**PLANNING AND ZONING COMMISSION  
CITY OF BETTENDORF  
SEPTEMBER 16, 2020 AT 5:30 PM  
CITY HALL COUNCIL CHAMBERS  
1609 STATE STREET**

**MINUTES  
PLANNING AND ZONING COMMISSION  
AUGUST 19, 2020  
5:30 P.M.**

56TH AVENUE DEVELOPMENT ADDITION

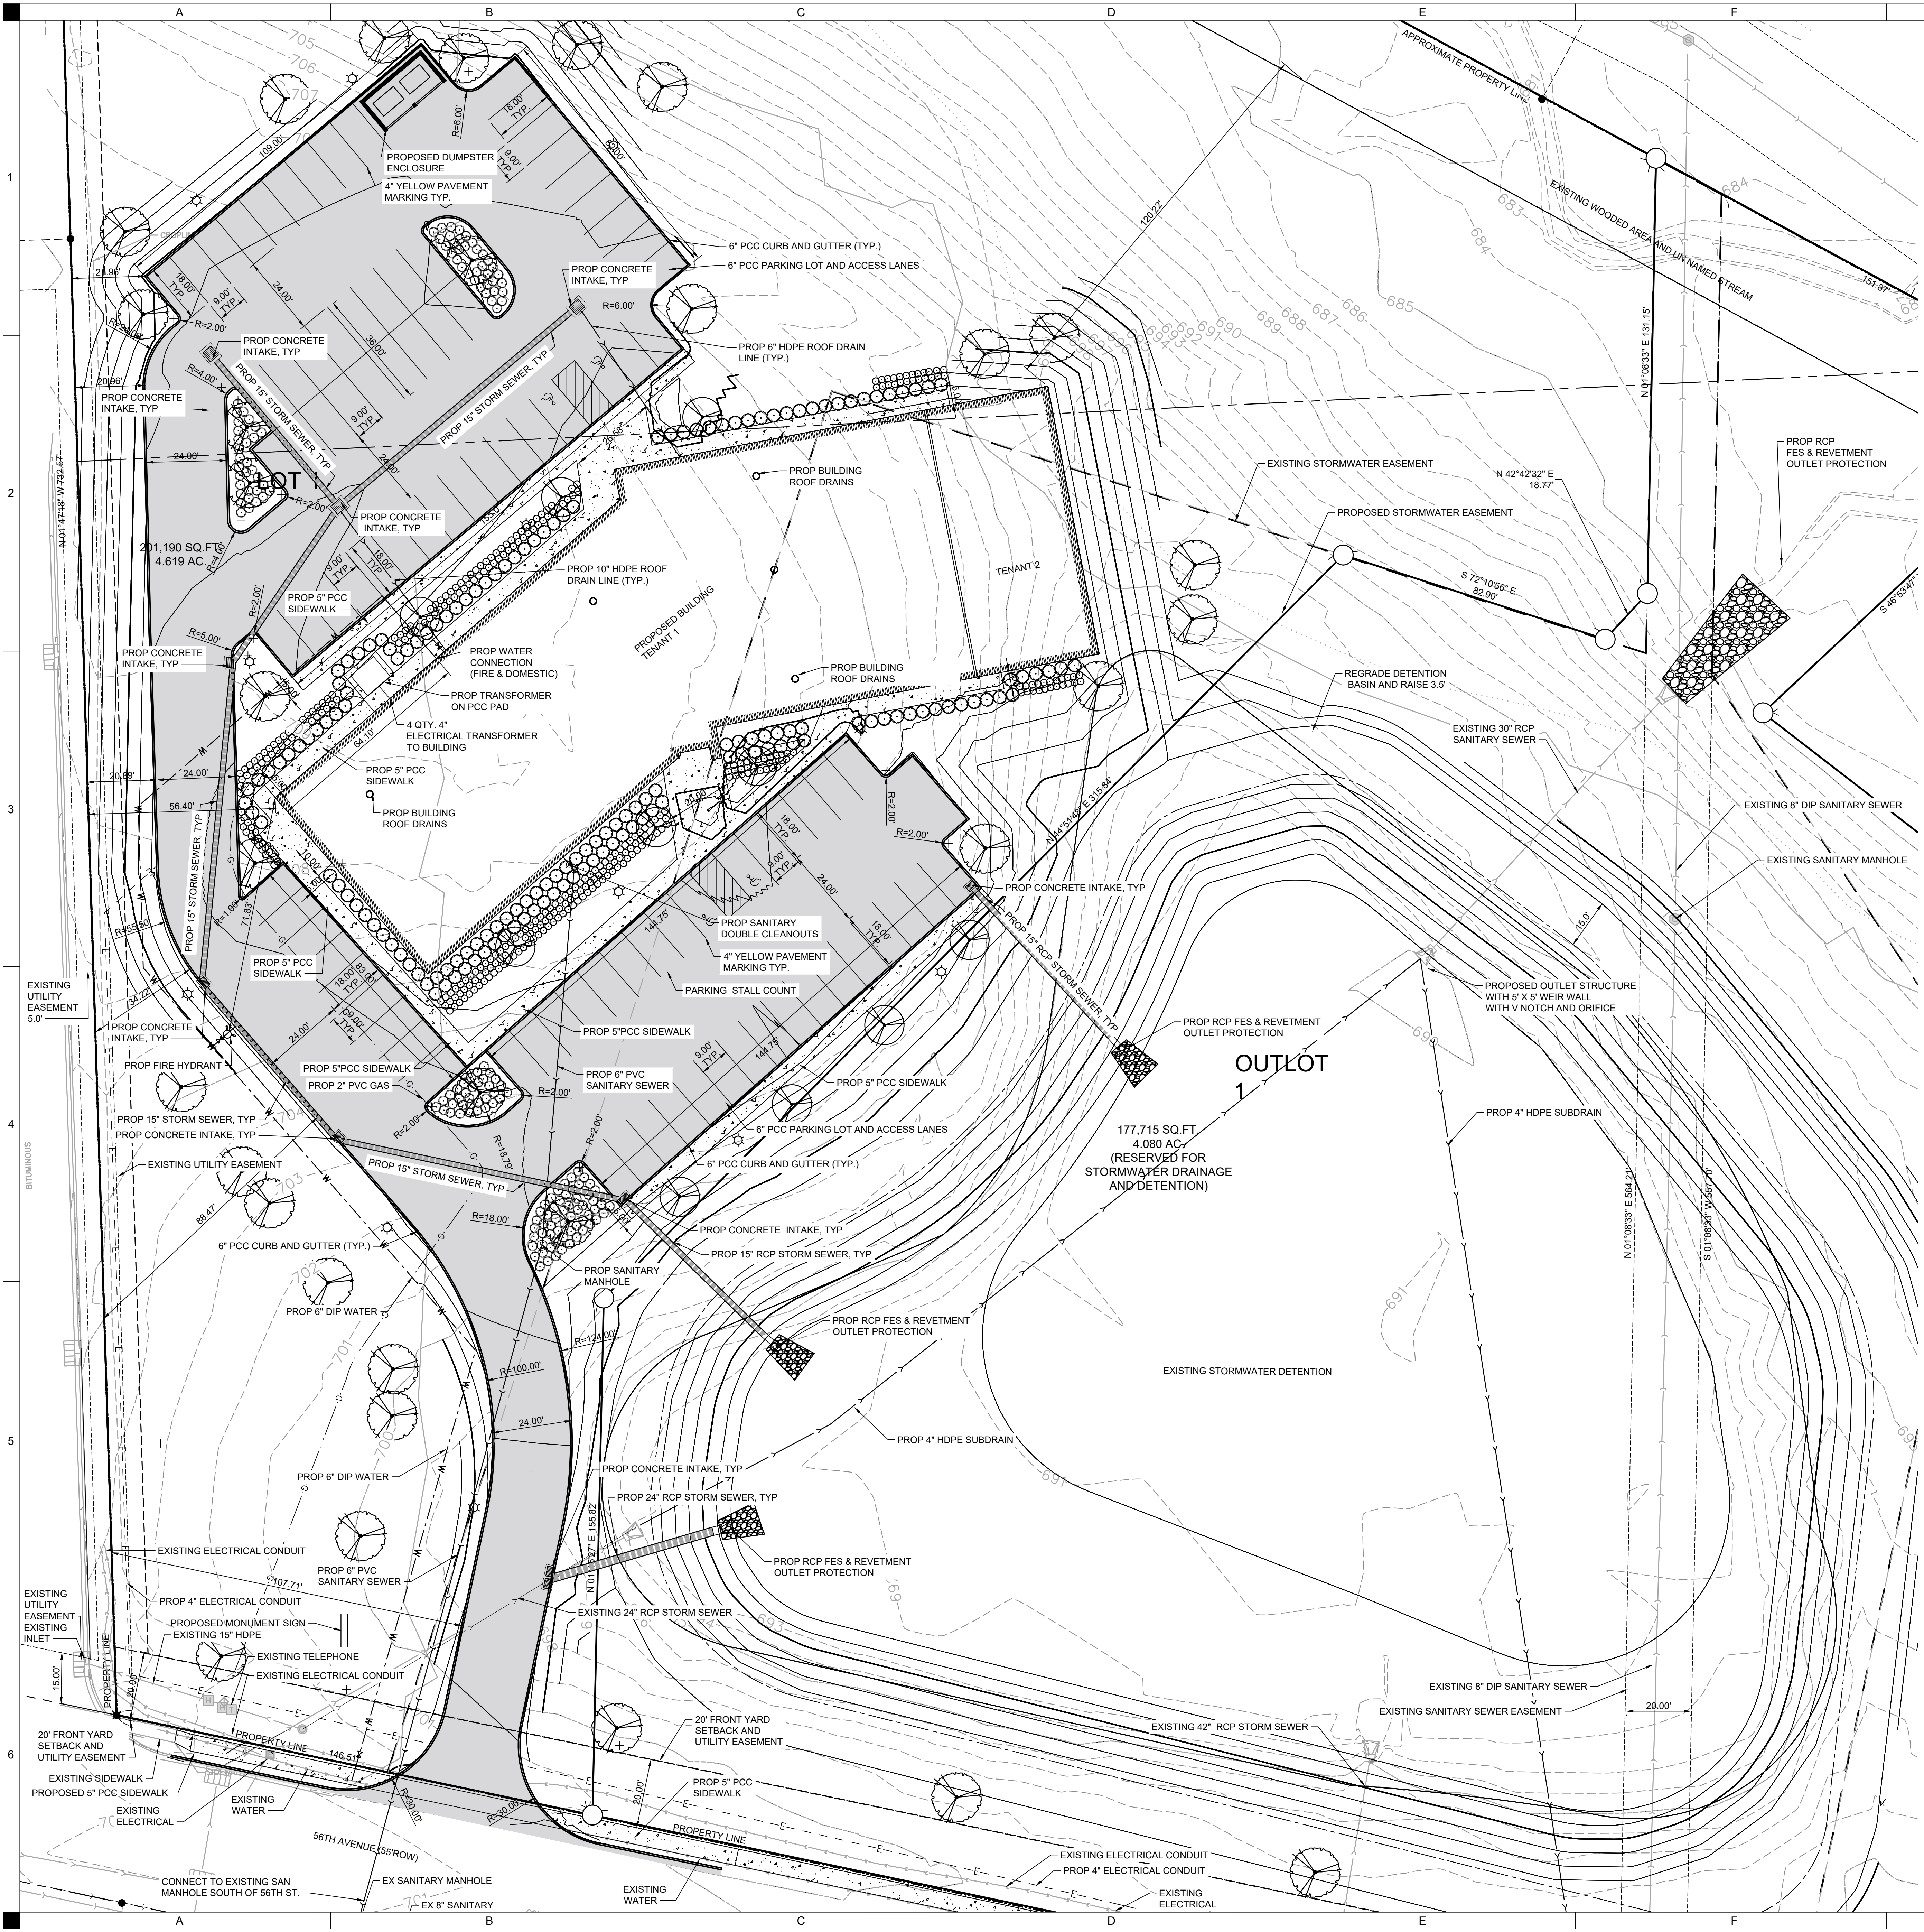
Storm water detention will be achieved using Outlot 1 as shown on the site development plan. All openings in the building must be above the elevation of the 100-year flood event to prevent flooding should the retention pond overtop.

Staff recommends approval of this site plan with the following conditions:

1. All landscaping shall be installed and maintained according to the approved landscape plan submitted and approved as part of the site development plan. If all plantings cannot be installed by the time the Certificate of Occupancy is requested, then a bond shall be posted equal to 150% of the of the cost of materials and labor for completion of the planting.
2. Compliance with all state, city, and federal legal provisions.
3. Dimensioning of Outlot 1 is required.
4. Show zoning boundaries on plat within subdivision.

**HY-VEE TO GO PICK UP IMPROVEMENTS**  
BETTENDORF, IOWA  
**OVERALL SITE LAYOUT**

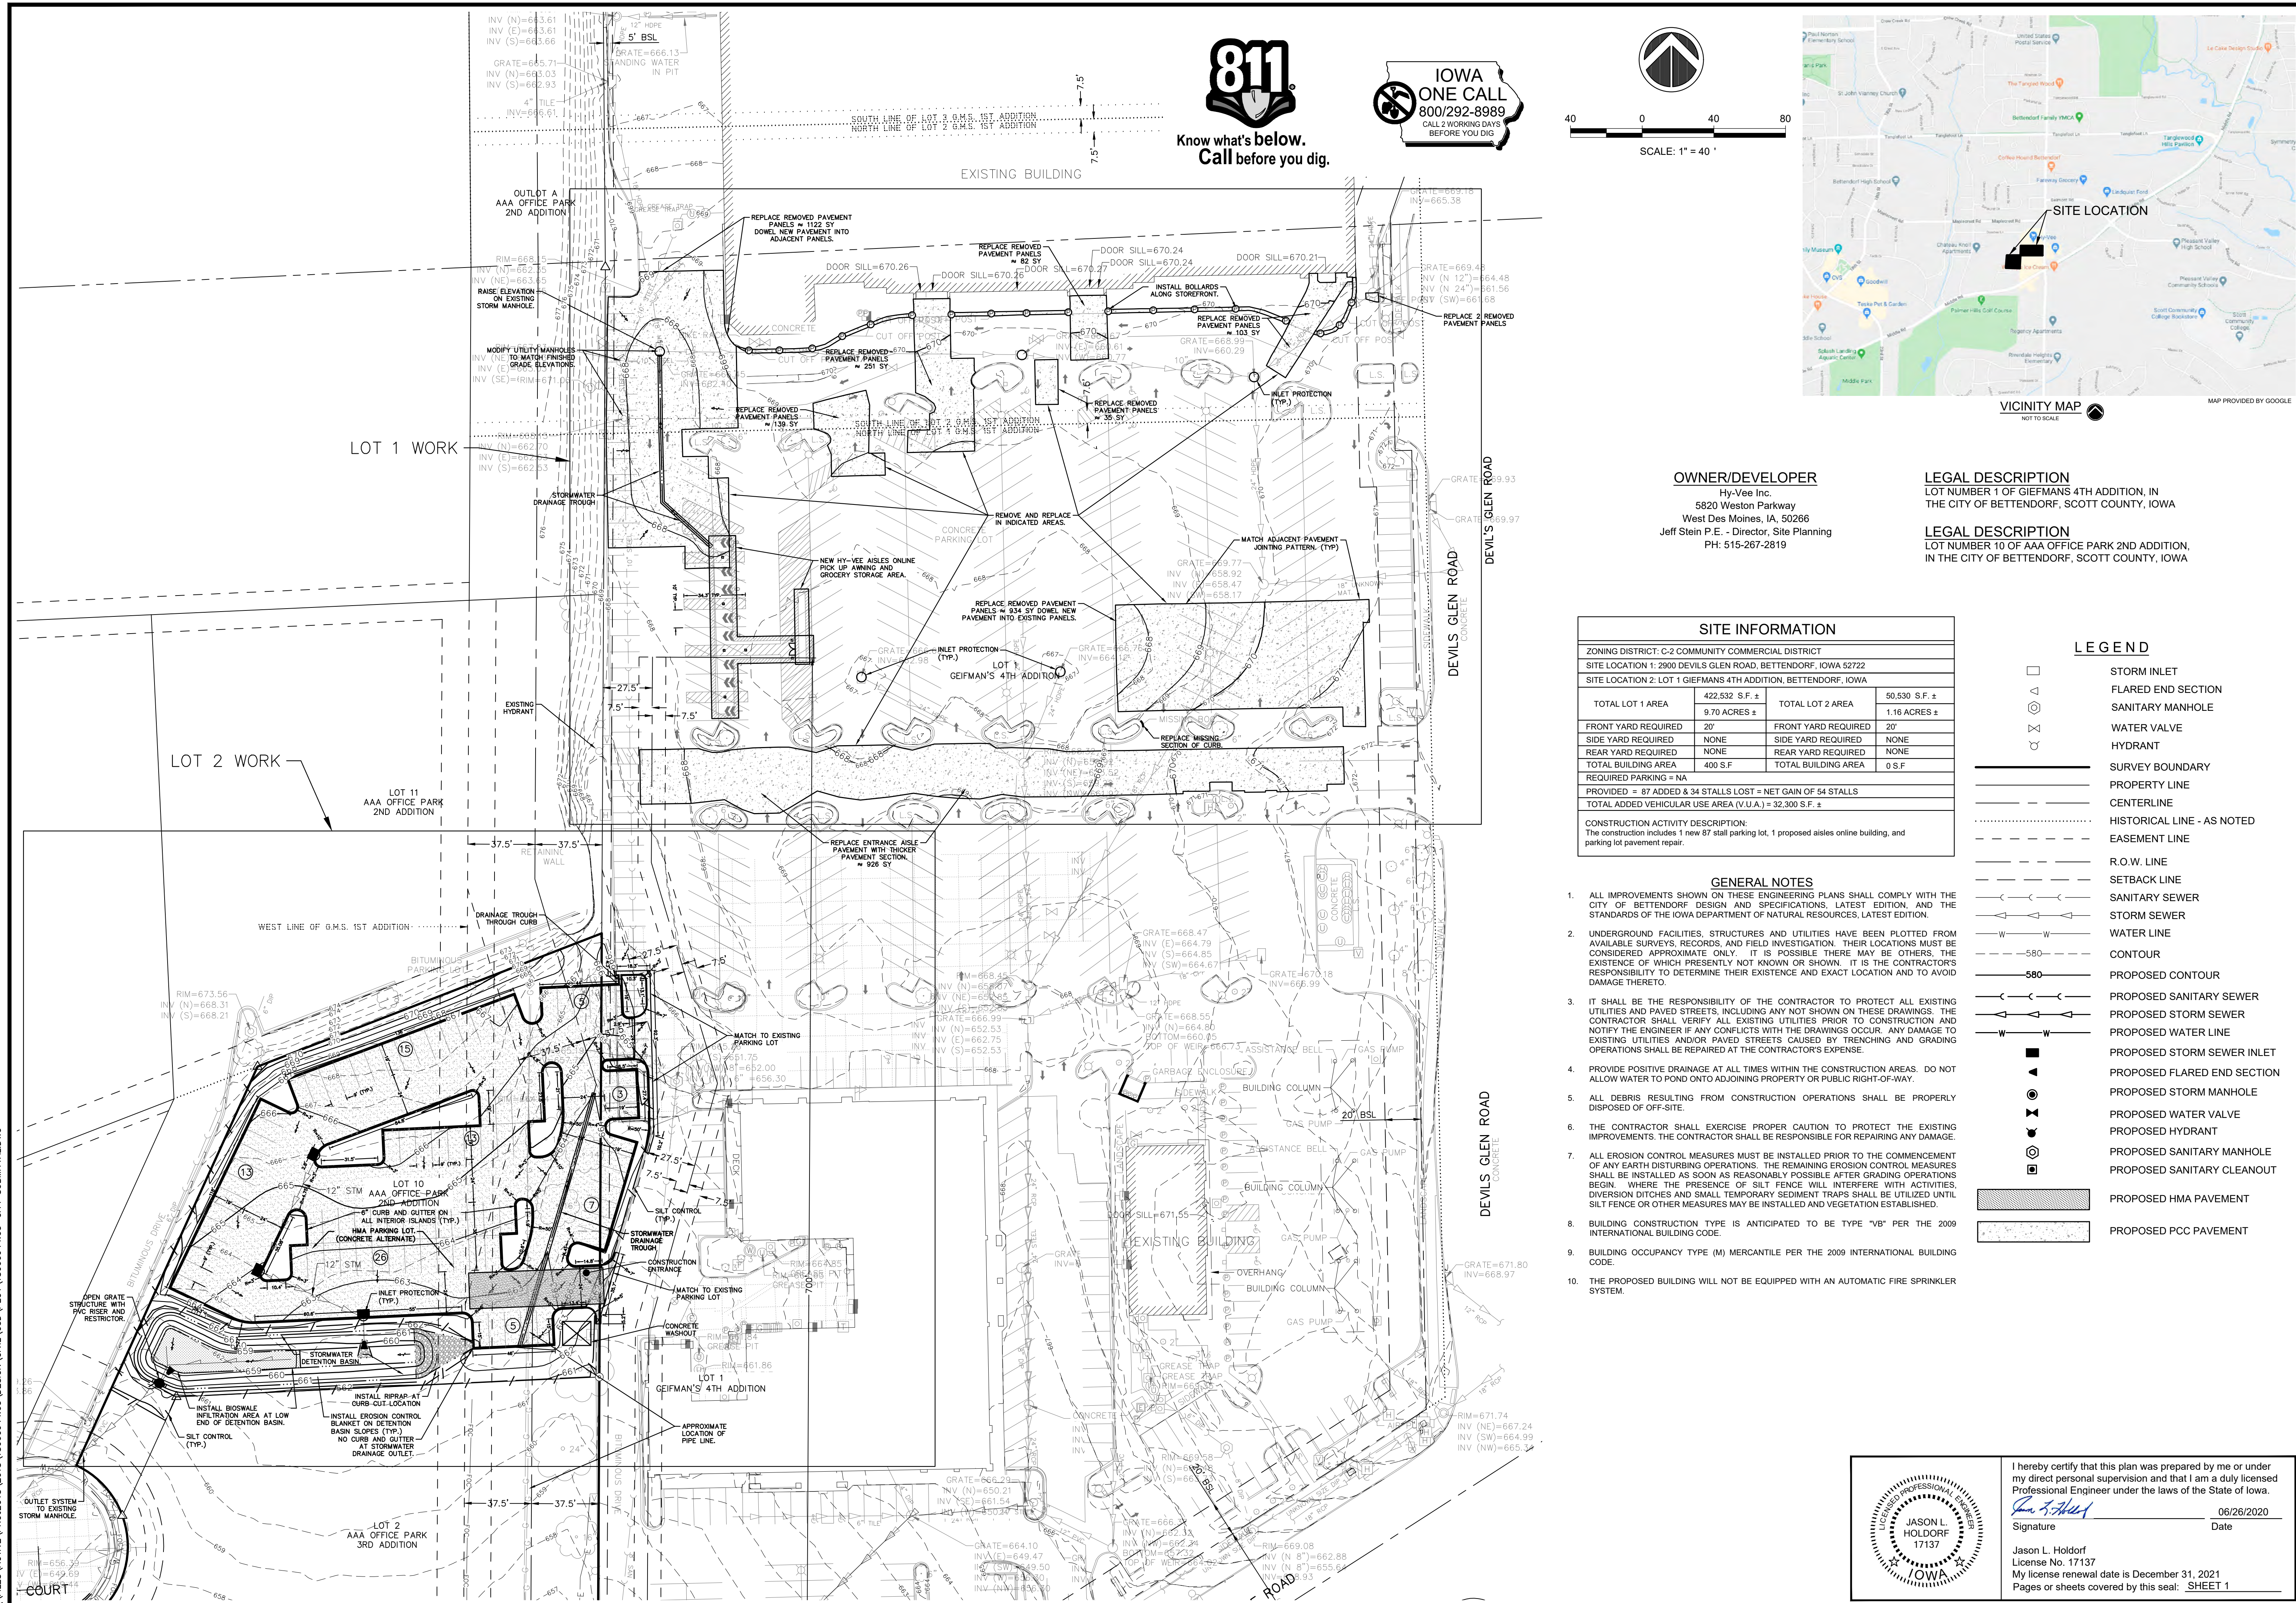
Storm water detention requirements will be met by use of two bioswales to filter water before exiting into the City's storm sewer system in Palmer Hills Court. The City Engineer must approve the calculations prior to City Council consideration of the site development plan. A detention easement agreement will be required to permit the conveyance of storm water.

Staff recommends the Planning and Zoning Commission recommend approval of the site development plan with the following conditions:

1. Approval of the site development plan does not waive any applicable city, state, or federal provisions as required by law.
2. City Engineer must approve the storm water detention design prior to City Council approval of the site development plan.
3. Access and detention easement agreements must be approved by the City Attorney prior City Council approval of the site development plan and be recorded at the Scott County Recorder's office.
4. Permission from the Magellan Pipeline Company is required for encroachment into the 75-foot pipeline easement area. Hy-Vee, Inc. must furnish written verification to the City prior to City Council consideration of the site development plan.
